**Proof of evidence on the interaction between the
Planned Cambridge South Infrastructure
Enhancements and the Medical Research Council laboratory**

DP1/OBJ/9

The Medical Research Council

January 2022

Fig A2.15: Maintenance access strategy for the LMB complex

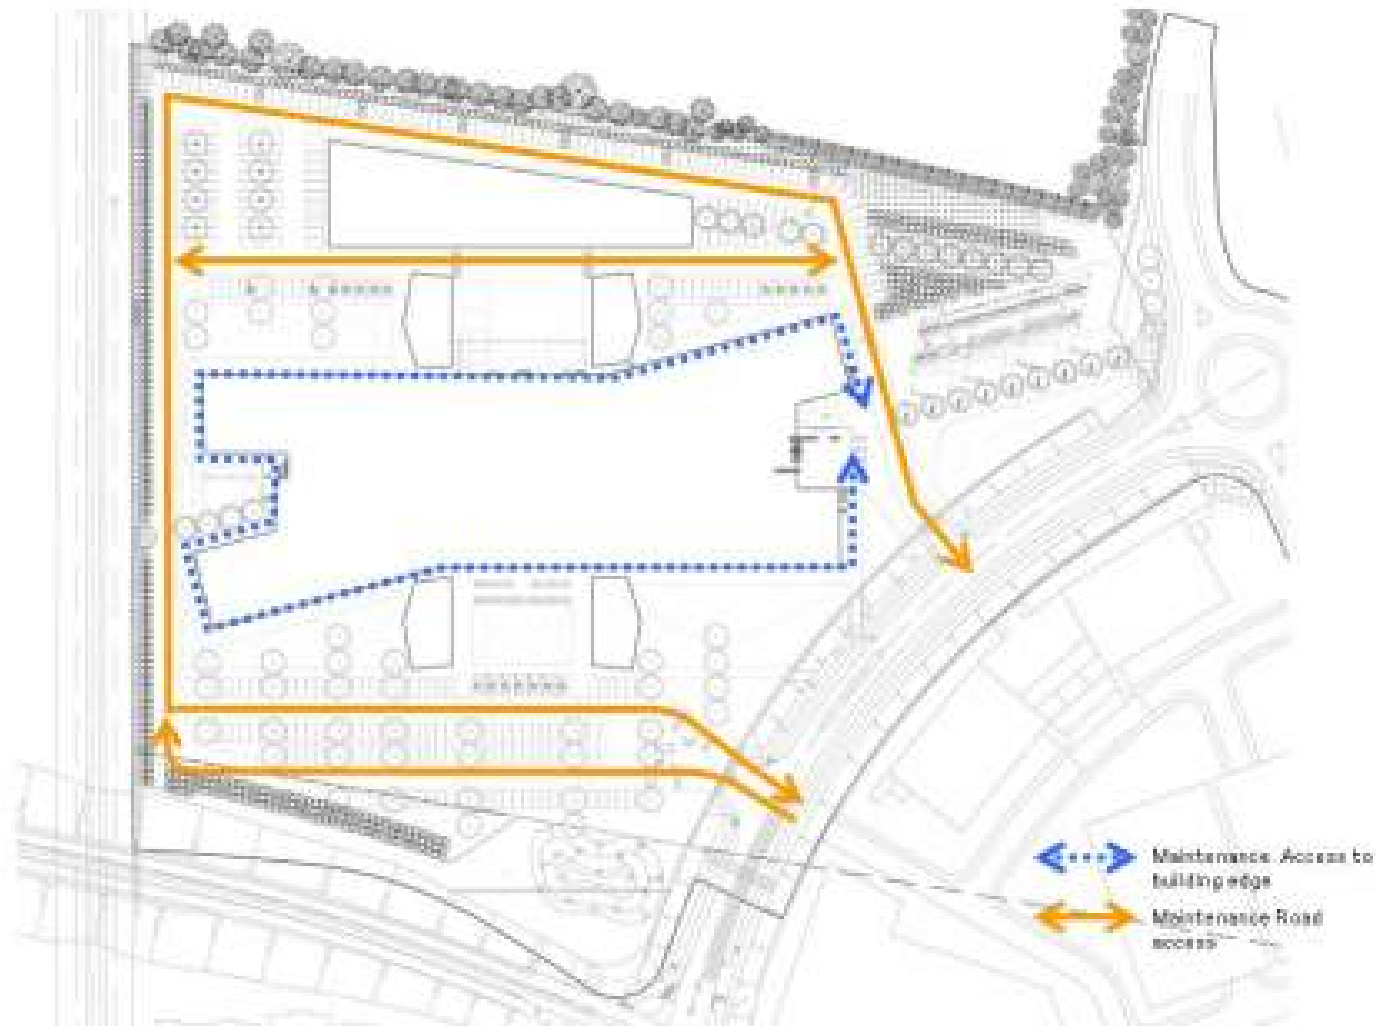
- 6.12 The main southern and western access roads within the LMB Laboratory land falls inside the red line boundary with Network Rail. Any encroachment on the circulatory road within the LMB site would have a potential impact on the day to day access for routine maintenance of the drainage system, this could be mitigated by carrying out maintenance and cleaning prior to commencement of the CSIE works and an emergency access strategy for the site put in place, as the LMB Laboratory operations rely on full access of the LMB Laboratory western road (Refer to Figure A2.15 and 2.17 in Appendix A2).

Fig A2.16: Extract of the Network Rail (Cambridge South Infrastructure Enhancement) order drawing 158454-ARC-00-ZZ-DRG-EMF-200002 sheet 2 of 10 overlaid with the LMB Laboratory legal boundary. Original access strategy (temporary and permanent)

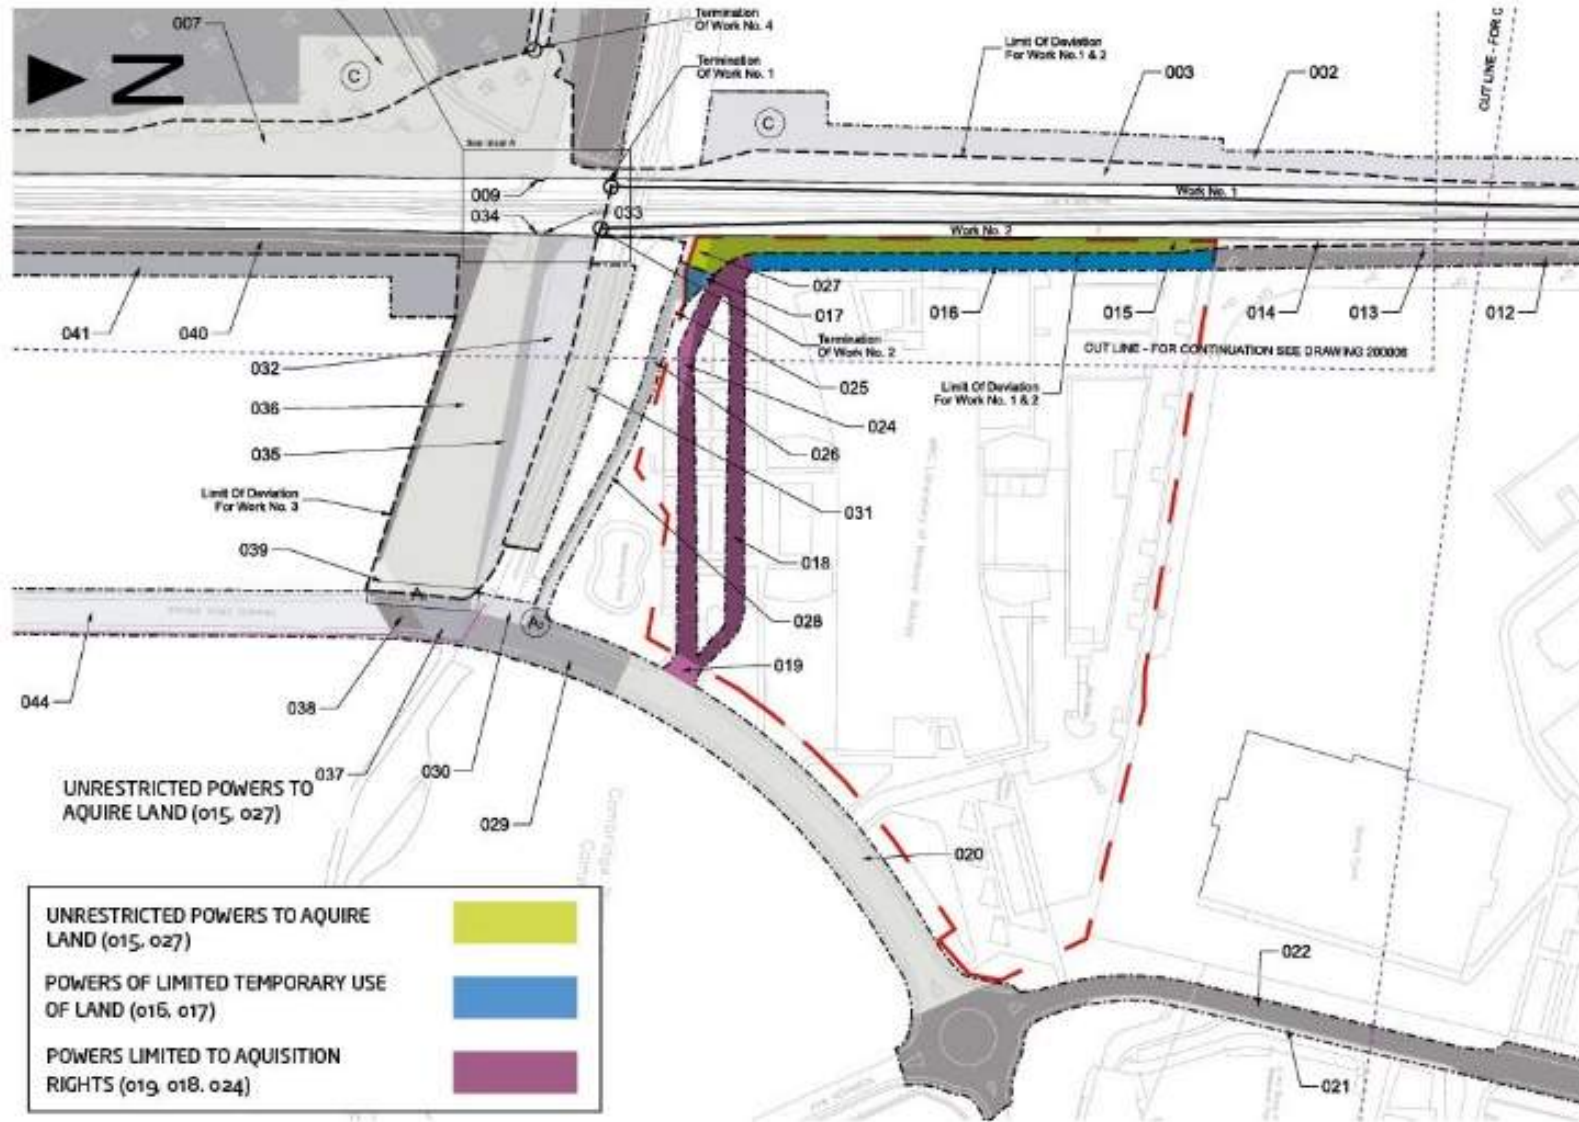
- 6.15 Figure A2.16 in Appendix A2 shows an overlay of the LMB ownership boundary on an extract of the Network Rail (Cambridge South Infrastructure Enhancements) order mapping. This overlay identifies three key interactions areas between the proposed works (in terms of temporary use of land, acquired land and acquisition rights) and the existing circulatory access road within the LMB land and the existing conveyance swale to the west.
